Figure 33-9a – Type 3/Type 4 Top Level PSE State Diagram (Part 1)

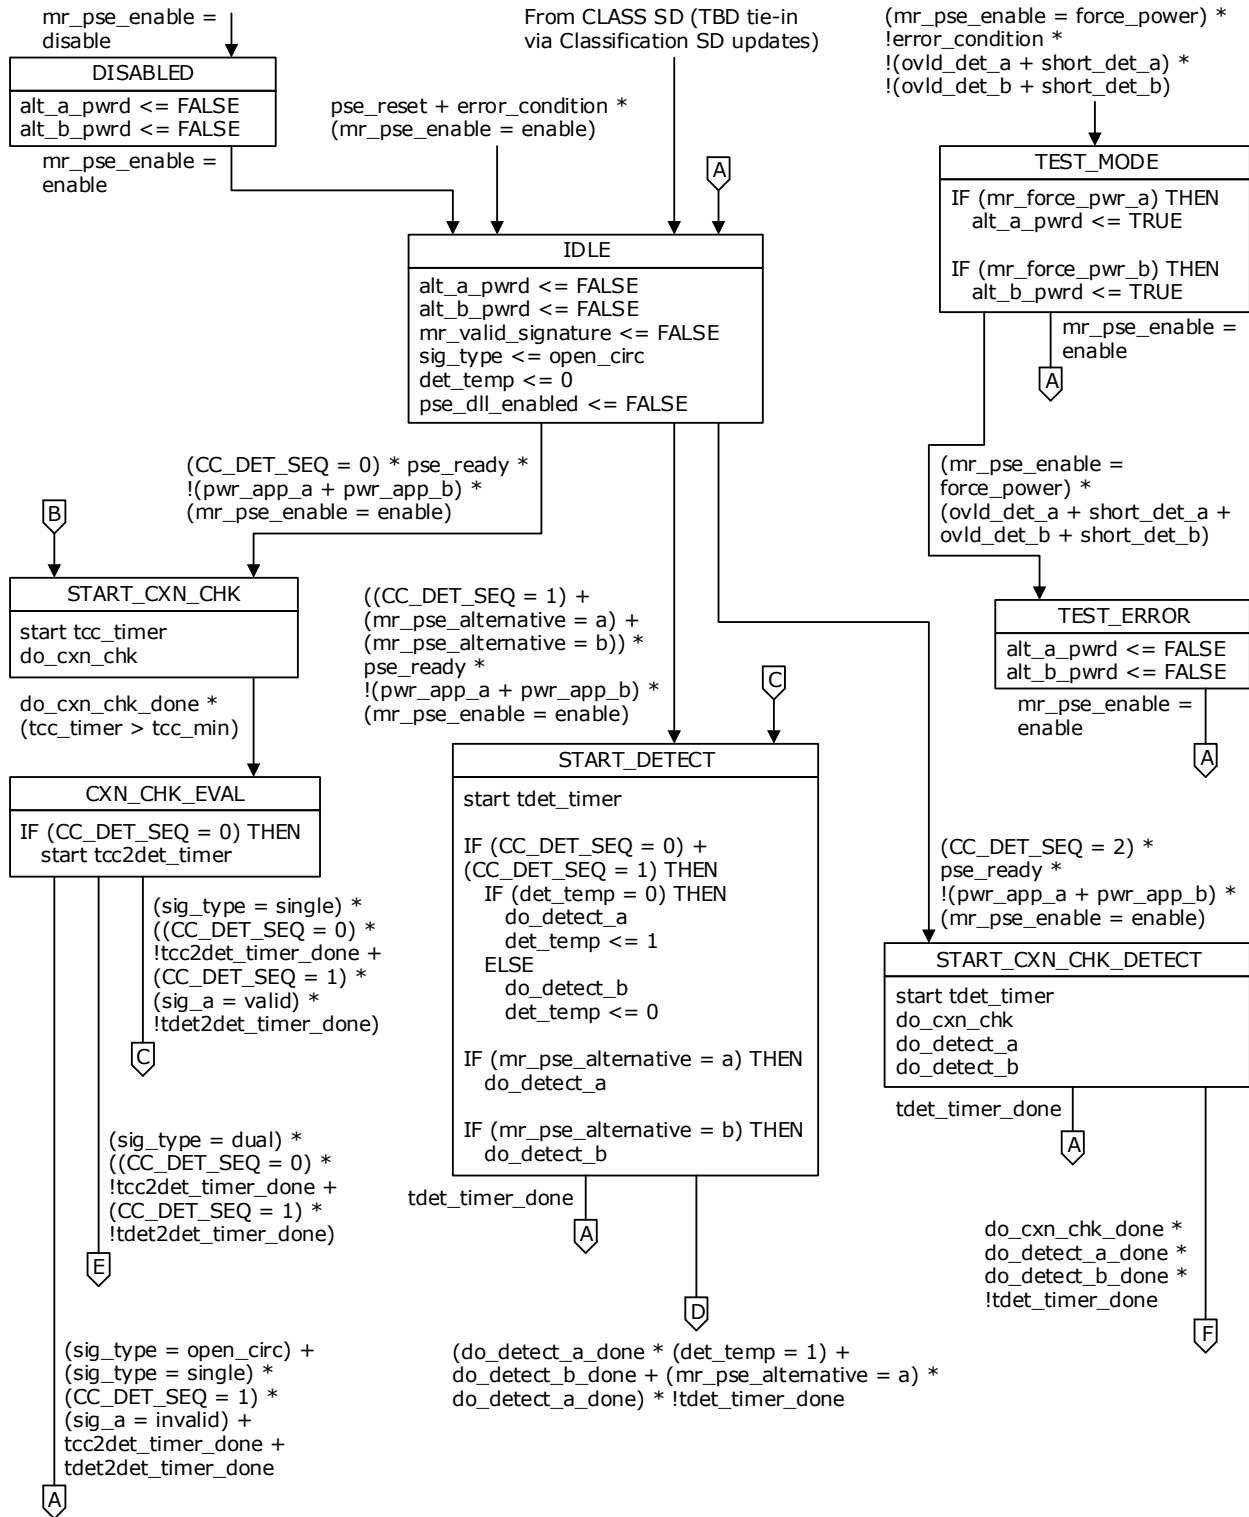
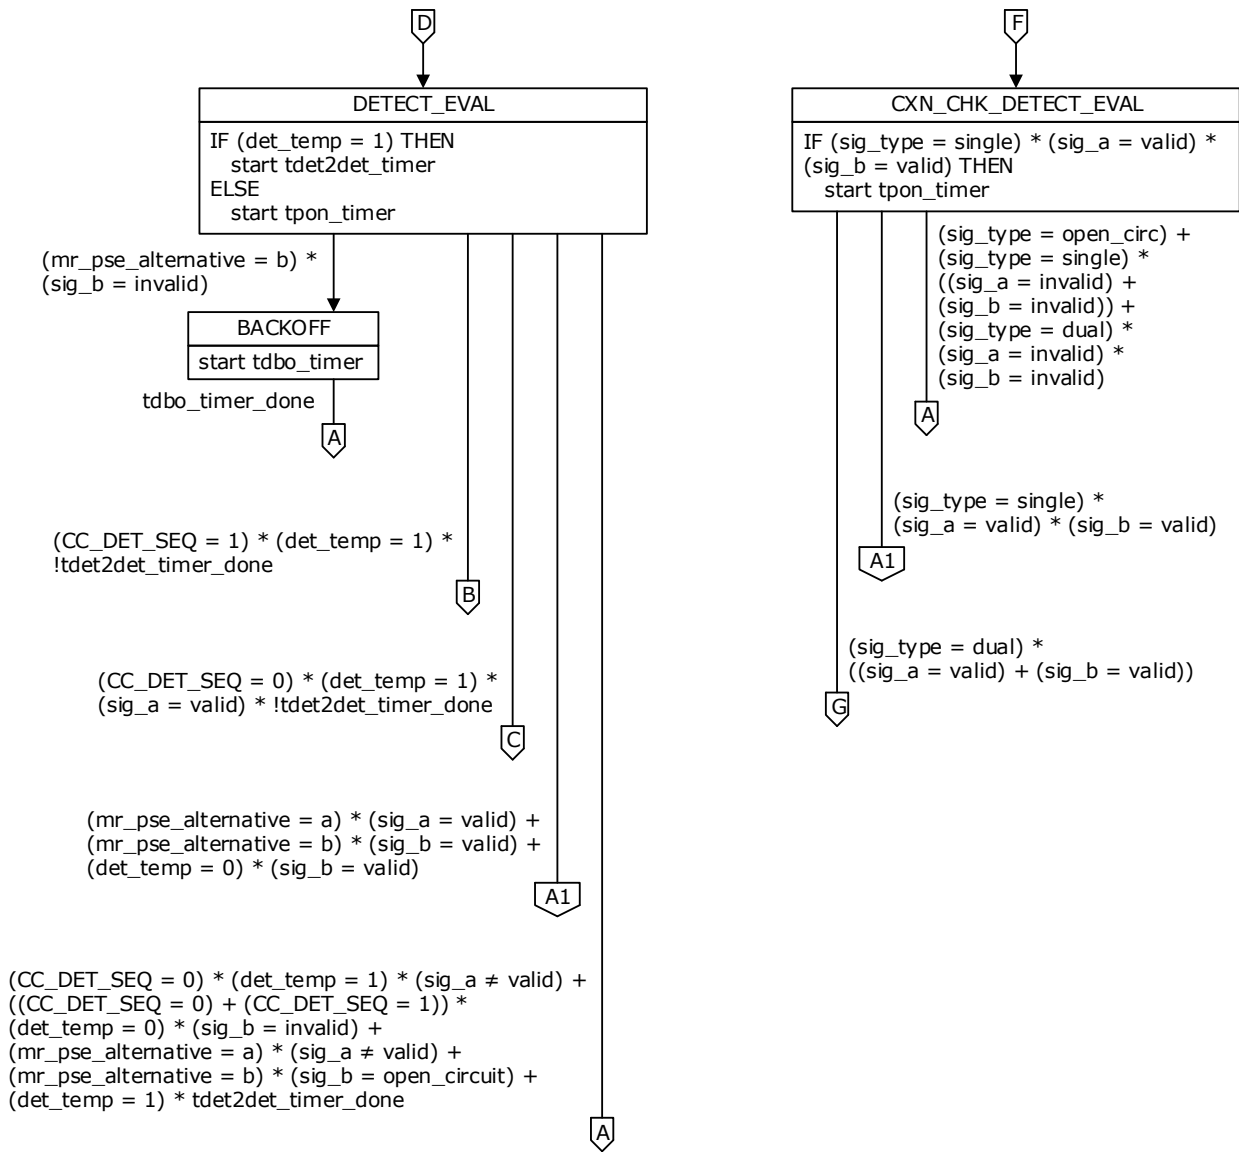
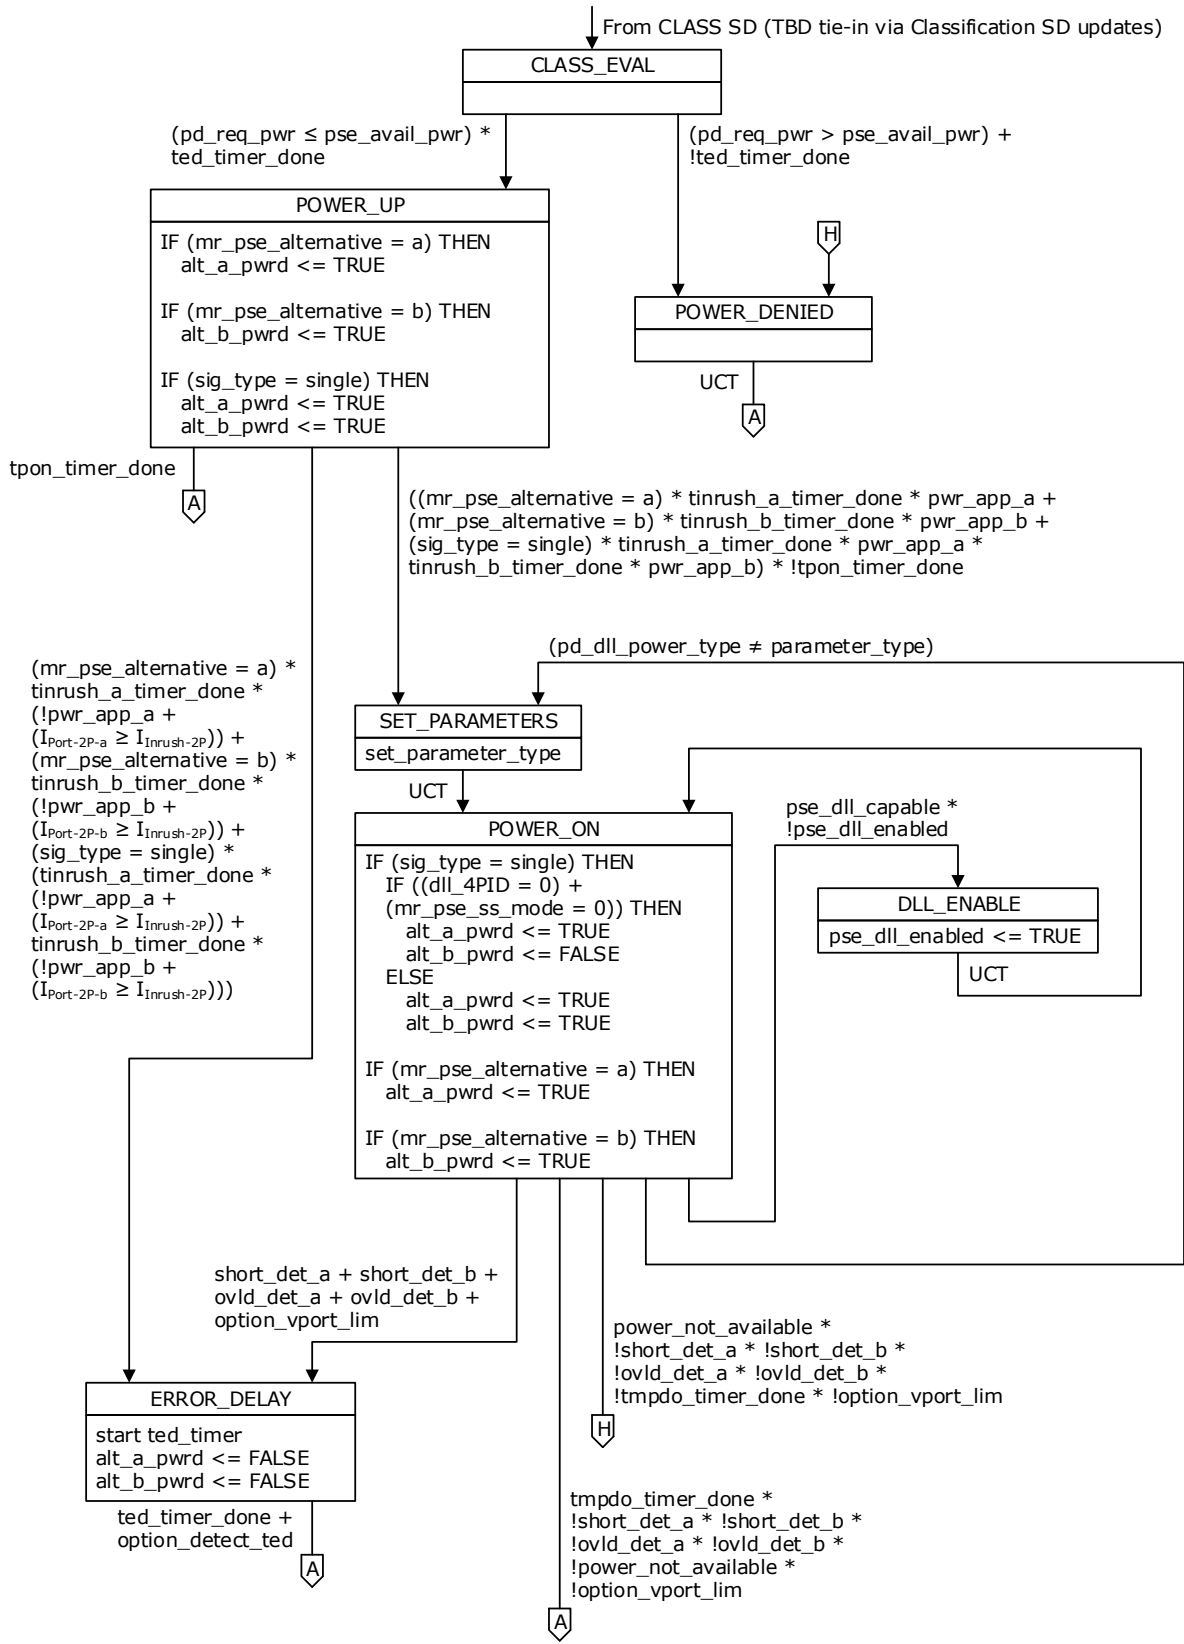
Remove Figure 33-9a, Figure 33-9b, Figure 33-9c, Figure 33-9d, Figure 33-9e, and Figure 33-9f.

Replace with the following figures.
